**Pacific Gas and
Electric Company®**

April 4, 2014

Re: Santa Cruz 115 kV Reinforcement Project (A.12-01-012)

Thank you for your February 27, 2014 request for additional alternative analysis information and data regarding Pacific Gas and Electric Company's (PG&E's) application (A. 12-01-012) and Proponent's Environmental Assessment (PEA) for a Permit to Construct the Santa Cruz 115 Kilovolt (kV) Reinforcement Project (Project).

Figure 2: Alternative 3 Overview Map

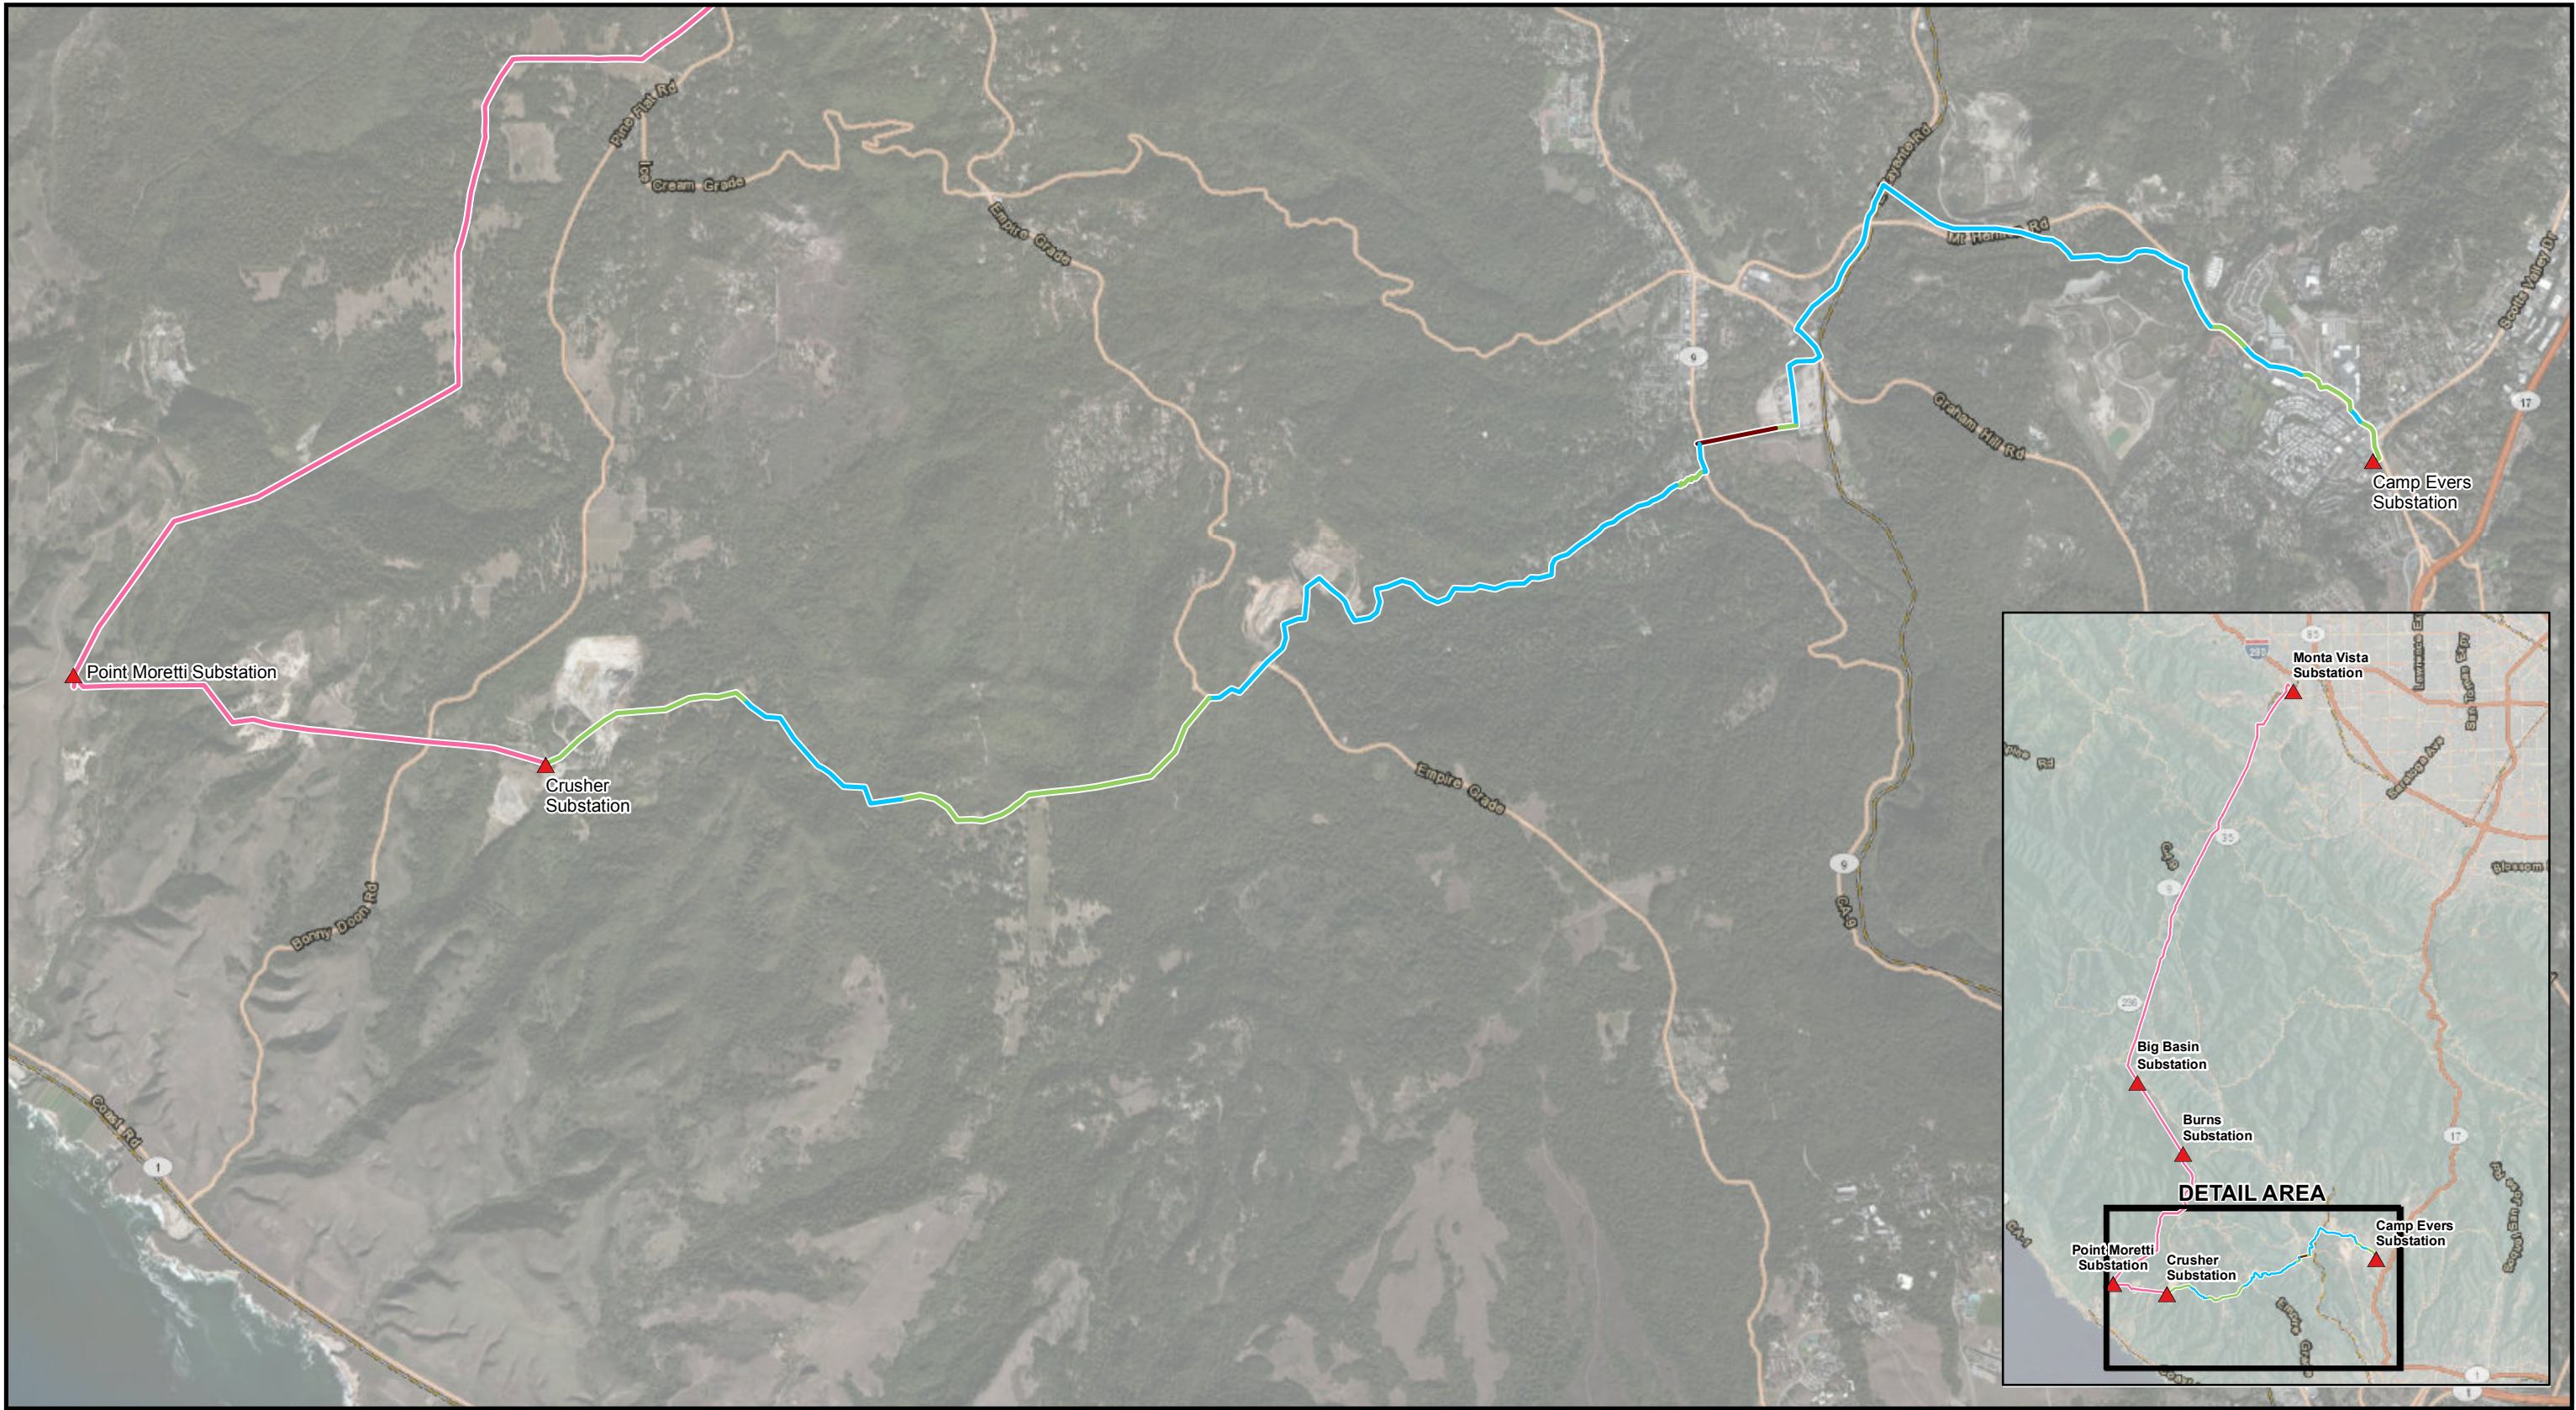
Please define the components of “rebuilding” (e.g., pole replacement? Substation work involved? Can be generally described) and associated cost implications (again, in general terms). Please provide a map indicating conceptually where new facilities would be located (or existing facilities expanded) so that we can assess the “substantial environmental impacts” conclusion.

PG&E understands Alternative 3 to involve rebuilding the existing, approximately 31.7-mile 60 kV line extending from Monta Vista Substation to Point Moretti Substation and then to Crusher Substation with a new 115 kV wood pole transmission line as depicted in Figure 2: Alternative 3 Overview Map, in Attachment A: Figures. A new 115 kV power line would be built from Crusher Substation and would interconnect with Camp Evers Substation. Two existing 60 kV substations are interconnected with the 60 kV line between Monta Vista Substation in the City of Cupertino and Point Moretti Substation in unincorporated Santa Cruz County near the community of Davenport, including:

Figure 4: Existing and Proposed Poles

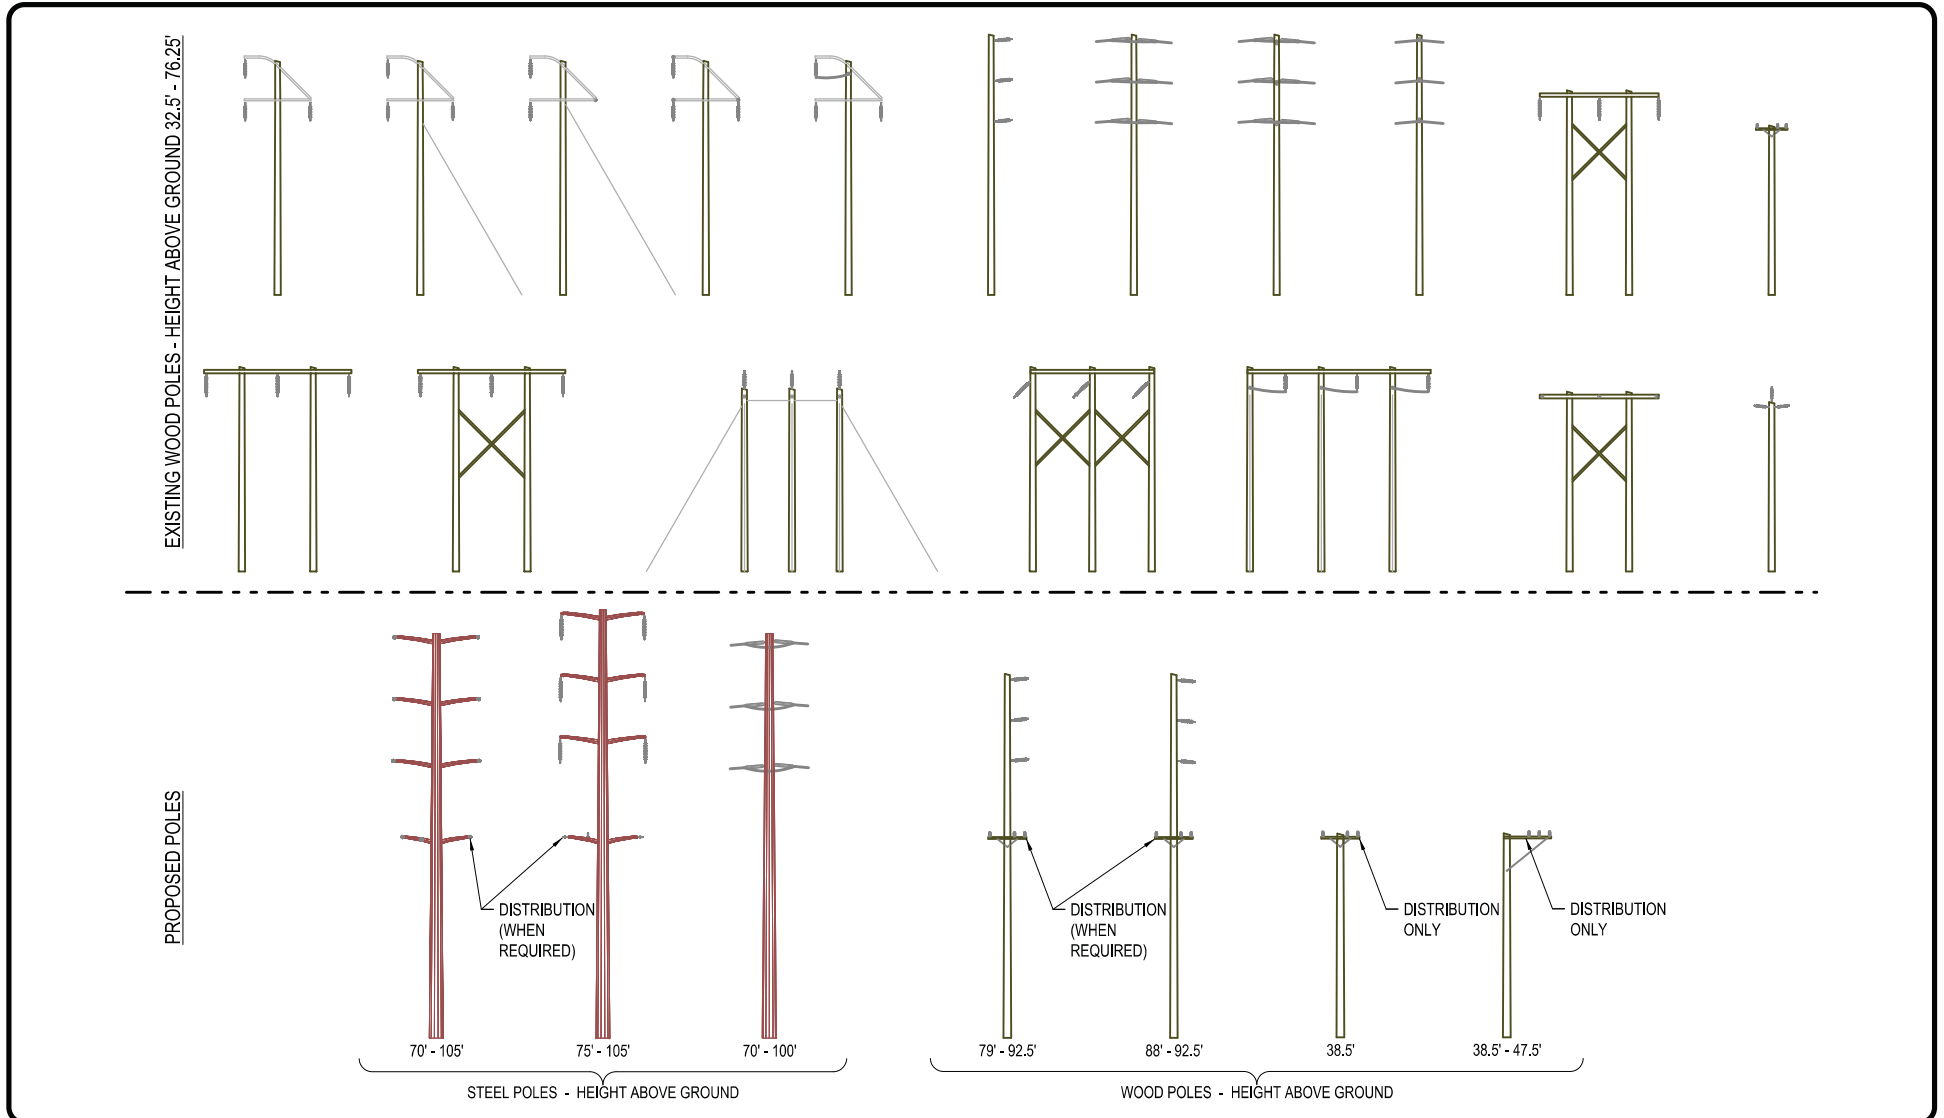
- 1. Does this alignment convert all existing wood poles to steel? Please indicate the types of steel poles and height ranges.*
- 2. Provide GIS files of the alignment.*
- 3. It is our understanding that the ROW in several locations must be moved approximately 20-30 feet due to proximity to a gas pipeline, in order to minimize the likelihood of explosion. Please identify these locations where the alignment must be moved due to the*

1. Alternative 4A would convert all existing single-circuit wood transmission poles to double-circuit TSPs. An overview of Alternative 4A is depicted in Figure 3: Alternative 4A Overview Map, in Attachment A: Figures. The TSPs would most likely be the same as those proposed for the Project, as shown in Figure 4: Existing and Proposed Poles, in Attachment A: Figures. Pole heights would range from 70 feet to 105 feet.
